# Access Compliance Report

## Public Rights-of-Way

### (Curb Ramps)

Intersection ID: 10021330	Main Street: BLAKENEY_HEATH_RD	Cross Street: N/A	Location: SW
ADA ID: FBB0E12CD934	Ramp Type: BlendTrans2	Initial Pass/Fail: Fail	Overall Compliance: No
Severity Score: 1.25			
Codes/Mitigation Info/Possible Solution		Field Measurements/Component Compliance

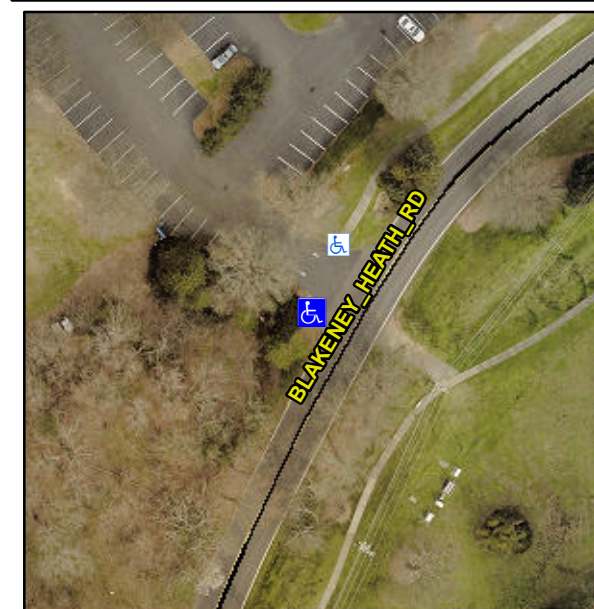
**SIDEWALK BEHIND RAMP SLANTS DOWN 5%, Entrance???**

**R304.5.3**

**Remove & Replace Curb Ramp With Two New Directional Ramps or Equivalent.**
